Pond Cleaning and Concrete Bottoms for Water Treatment Plant (WTP)

Project #1602

ADDENDUM no. 1

Corrections, Notes and Clarifications

Scale: Not to Scale Drawn By: Justin Mooney 3/16/18 Sheet: 2 of 2

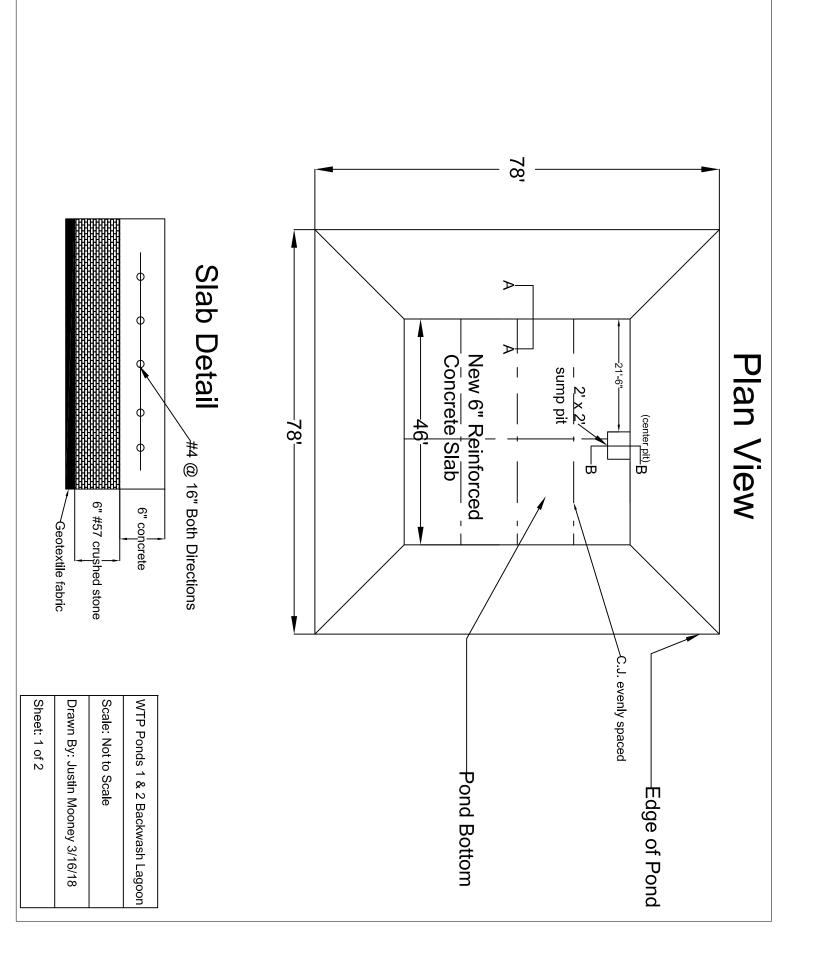
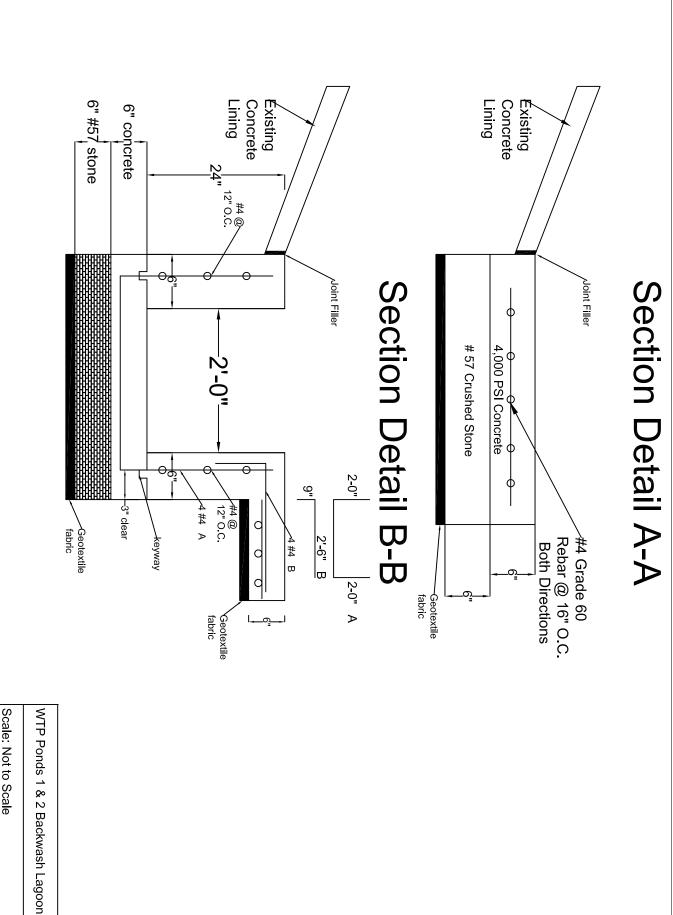
- 9. Revisions to plan view and section detail drawings to add saw cut contraction joints (CJ) on slab, geotextile fabric at bottom of #57 crushed stone and joint filler between existing concrete lining and new 6-in. slab. See attached drawing sheet 1 and 2.
